July 25, 2014

RE: Draft Bay Delta Conservation Plan and Associated Draft Environmental Impact Report/Environmental Impact Statement (BDCP EIR/EIS)

These comments are submitted in relation to the Bay Delta Conservation Plan ("BDCP" or the "Project") and associated public review draft environmental documents (EIR/EIS) on behalf of the Friends of Stone Lakes National Wildlife Refuge ("FSL," formerly known as the Stone Lakes National Wildlife Refuge Association). FSL is a volunteer, nonprofit organization dedicated to the conservation, protection, enhancement and promotion of the Stone Lakes National Wildlife Refuge ("Stone Lakes NWR" or "Refuge"). The comments are solely those of FSL and are independent of Stone Lakes NWR staff and the U.S. Fish and Wildlife Service ("USFWS").

EXHIBIT I

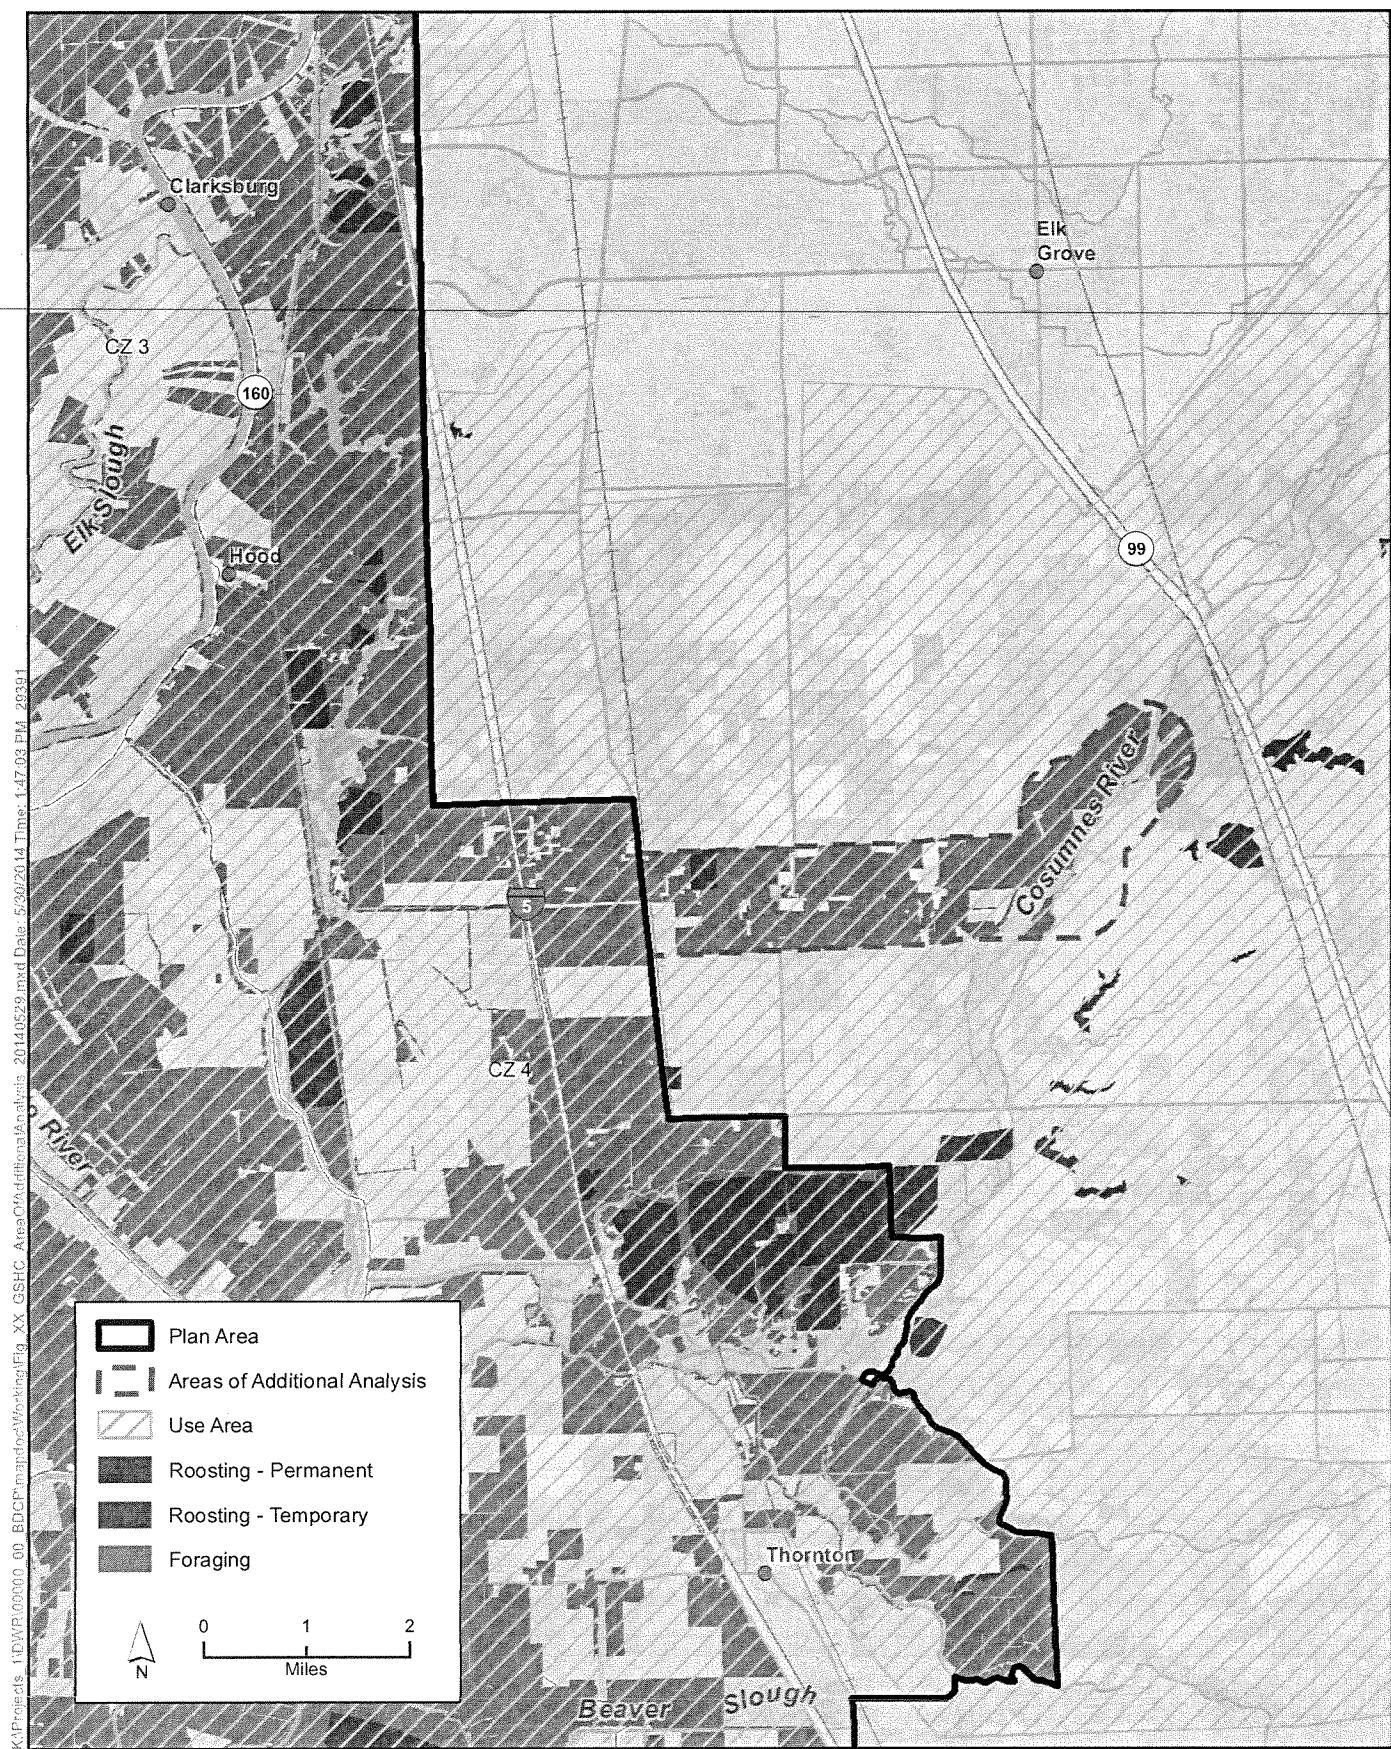
⁷ While Table 1 refers to the transmission lines as within the Plan Area, (BDCP, Appendix 5.J.C, page 4), part of the permanent transmission lines would be in what is referred to as an "area of additional study" (see Exhibit I).

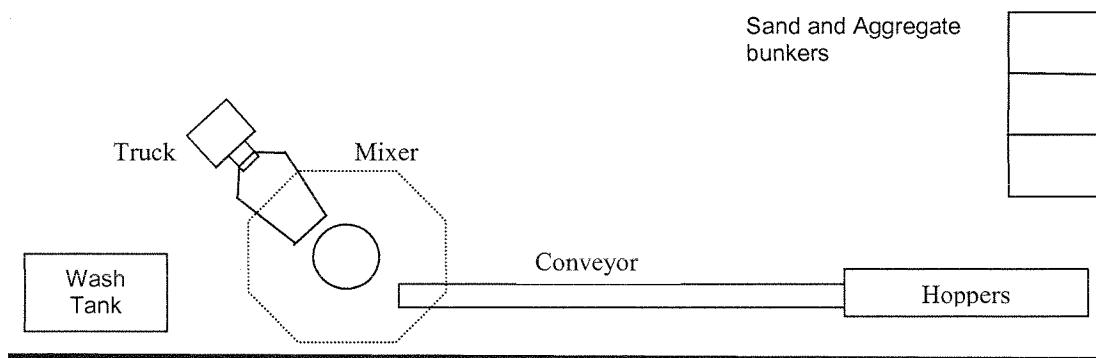
1. The batching plant should be enclosed along its southern and eastern edges by a three metre high noise screen. It should be designed to screen the aggregate bunkers, and to minimise noise propagation in the south and east directions.
2. Concrete truck drum speeds must be limited to 9 rpm either through management procedures or by fitting a limiter to the drum speed control.
3. The hoppers should be lined with a resilient surface or constructed from damped steel sheet to reduce impact noise (this should reduce the noise generated at high level by at least 5 dB).
4. The concrete trucks should use the suggested route to avoid movements close to the eastern boundary.
